SEWAGE DISPOSAL SYSTEM

HOWARD COUNTY HEALTH DEPARTMENT

REPAIR - PURPOSE - Commercial building addition for beauty salon.

RE: Percolation test results  
Purpose: Building Addition  
Property ID: 1691 Woodstock Road  
Tax Map 10, Parcel 106

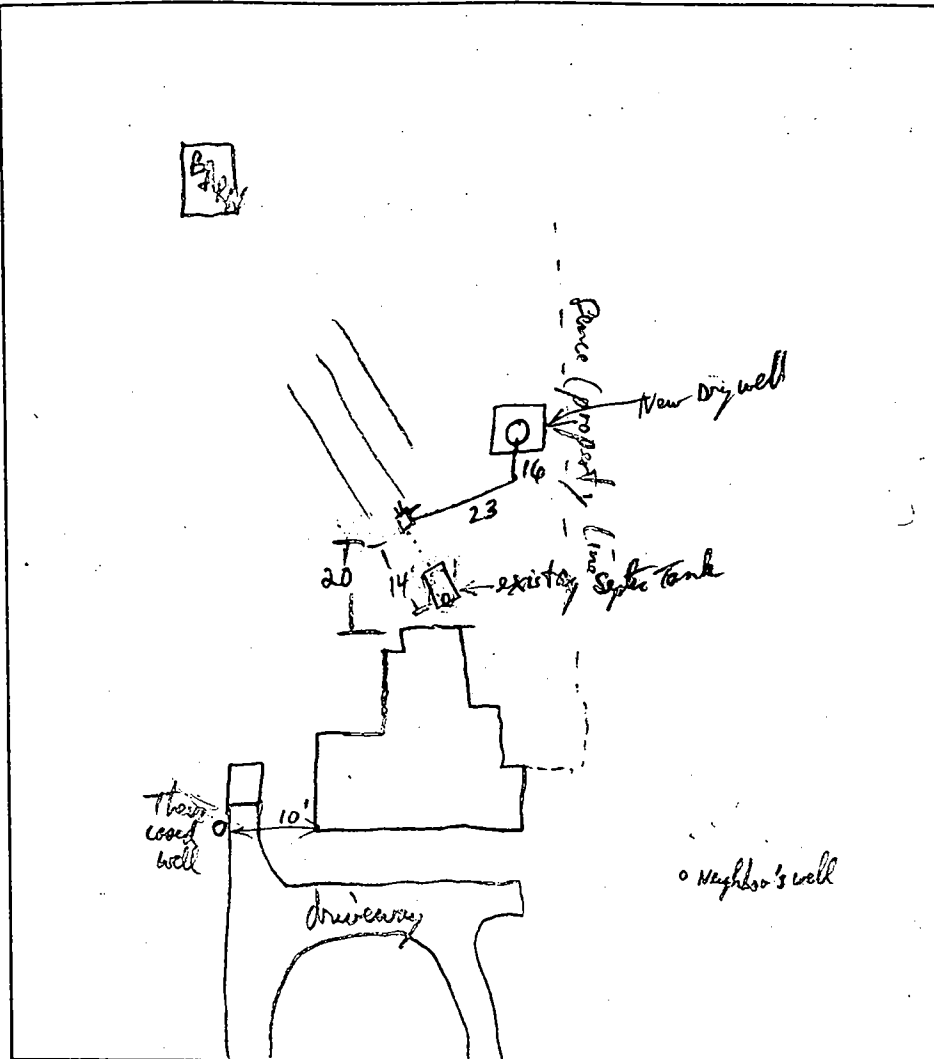
Open dry well hole is deep enough, good mix soil as per per hole A.

INSPECTION COMMENTS: OK to proceed with laying block, call when dry well hole is to be set,  
OK to gravel fill or building up layers of block. RPT 3/9/00 Using 12" wide concrete block  
"cylinder" ring wall has been built 9 ft deep and #1 clean stone fill placed between block wall and  
sides of 15' x 15' wide excavating pit. Needs to place inlet piping & lid and paper cover before covering.  
Call when ready, RPT/ 3/17/00  
3/29/00 OK TO FINISH & COVER (MR)

LINEAR FEET OF TRENCH REQUIRED Dry well 15' x 15' wide, 12 ft deep, 6 ft effective depth, OK to use 9" rings + 9 ft of gravel + 3 ft down over lid, OK to use 6" diam. cleanout pipe

LOCATION: Connect DW via same Dist. Box as existing Trenches. Owners - says they'll use concrete blocks - can't get touch to deliver preformed rings

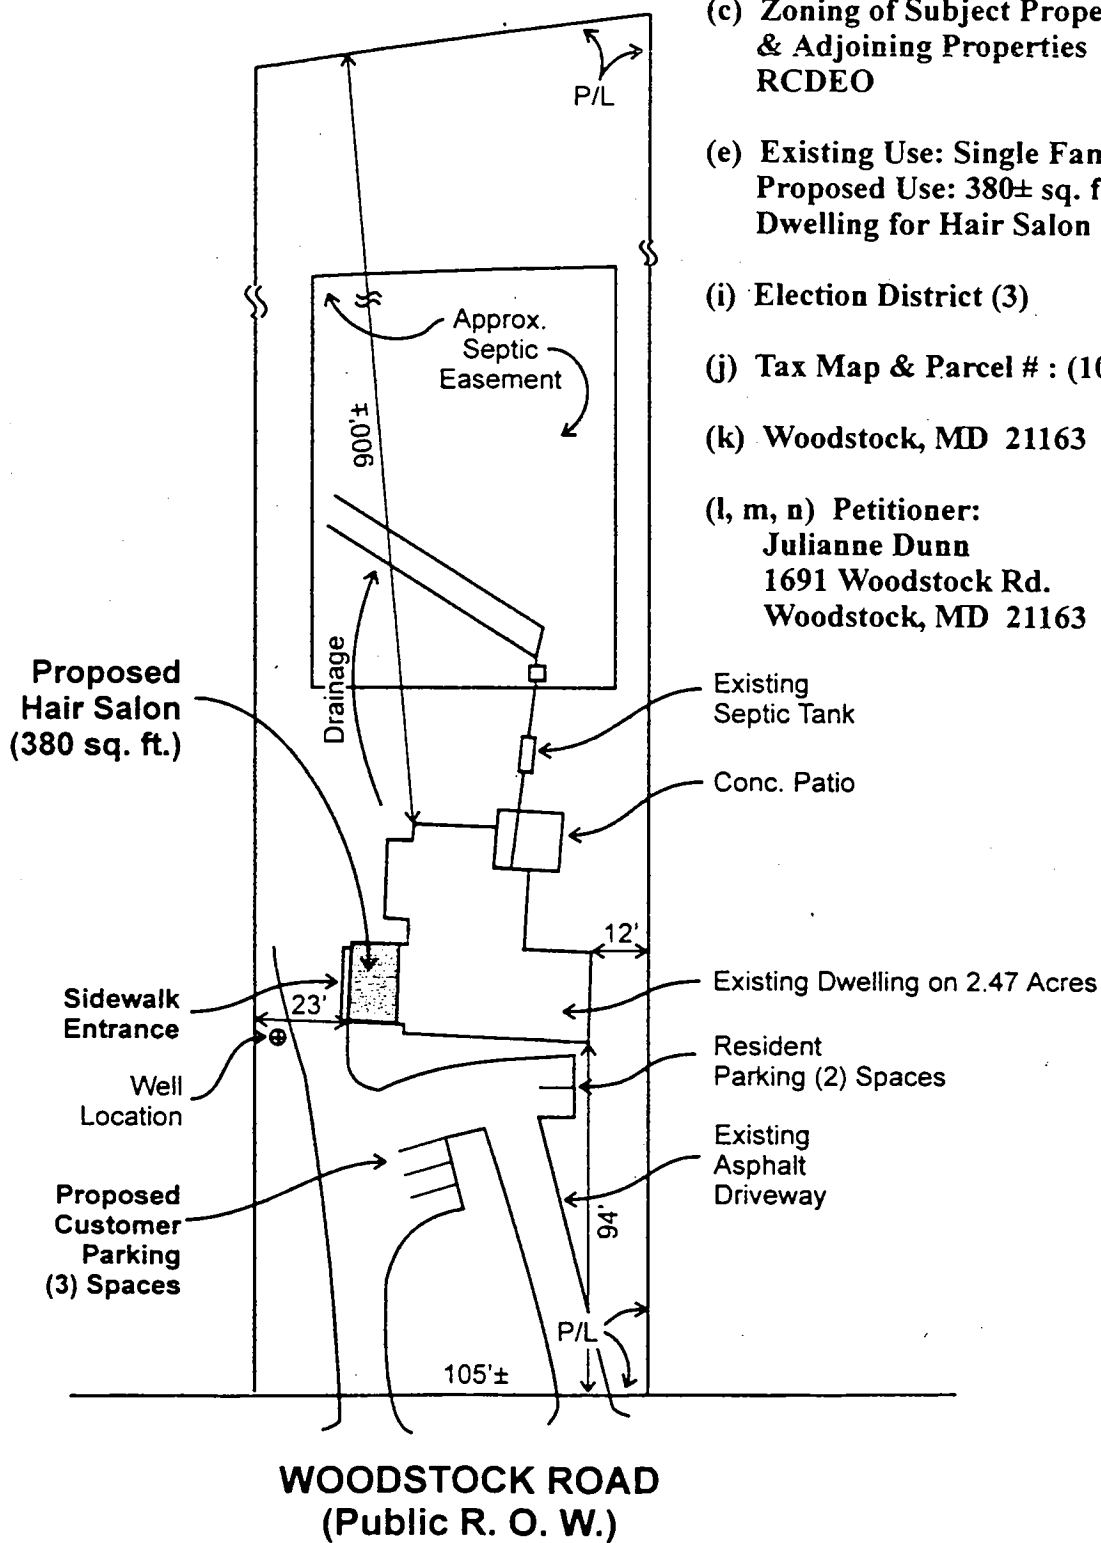
REMARKS Rock is a bit like heavy granite schist (area tested is >10,000 sq ft extra Septic area)

TYPE OF SOIL Chalky / loam OK for 2 Percolation sets if want - OK to place

TESTED BY R.P. [Signature] Repair Dry cell in area of Test Hole to measure time

TRENCH DESIGN DATA: AVERAGE PERCOLATION TIME 3 min TRENCH WIDTH 2

INLET DEPTH 3-3 1/2 MAXIMUM BOTTOM DEPTH 7 1/2 SQ. FT./BEDROOM 180
